DEVELOPMENT REVIEW BOARD REPORT

| CASE NUMBER/ PROJECT NAME | 66-DR-2005 J W Harris Building Remodel/Addition | | |
| REQUEST | Request approval of a site plan, elevations, and landscaping to remodel an existing building, including showroom expansion and addition of a residential component. | | |

Stipulations for Case: J. W. Harris Building Remodel/Expansion 66-DR-2005

LA-1

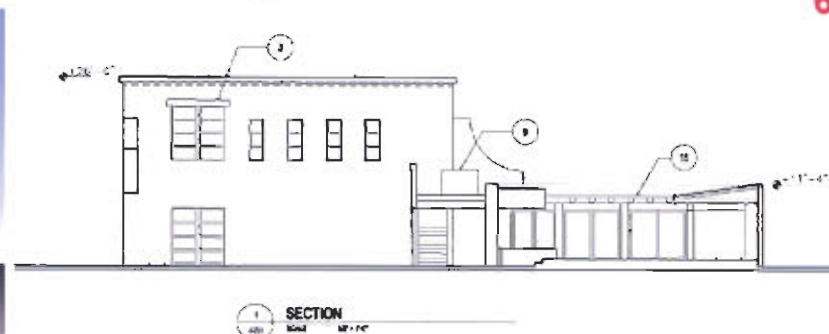
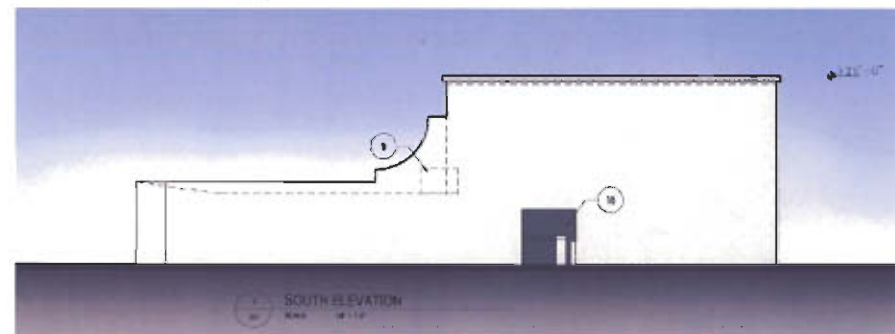
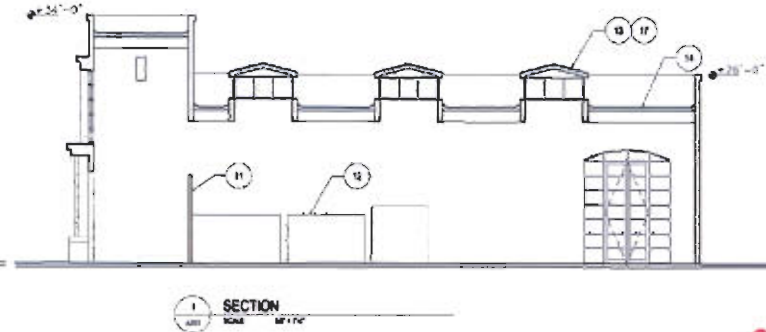
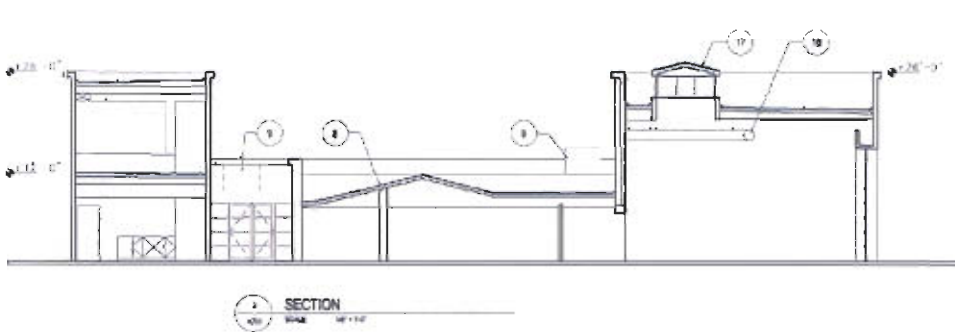
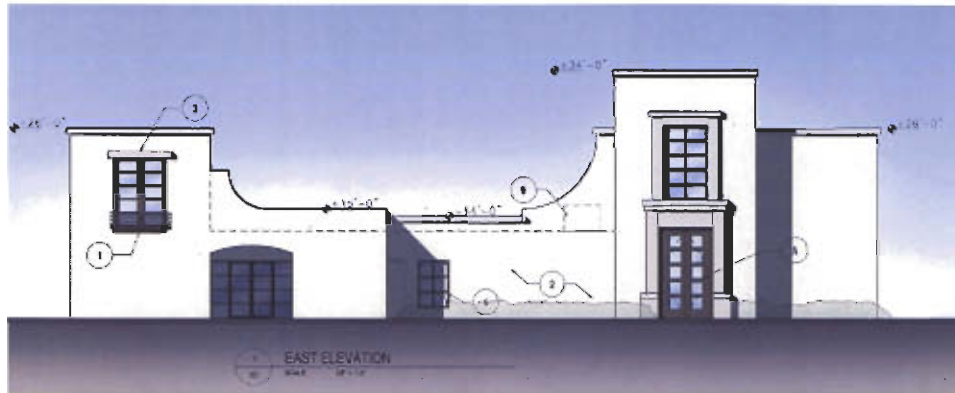
- c. Landscaping, including quantity, size, and location of materials shall be installed to be consistent with the conceptual landscape plan submitted by Jose G. Aguirre Design Group with a staff receipt date of 9/13/2005.

8. *No ground cover, succulent, shrub, or accent plant species with a maximum regional height growth habit greater than two feet shall be placed within any site visibility triangle defined by the City of Scottsdale*
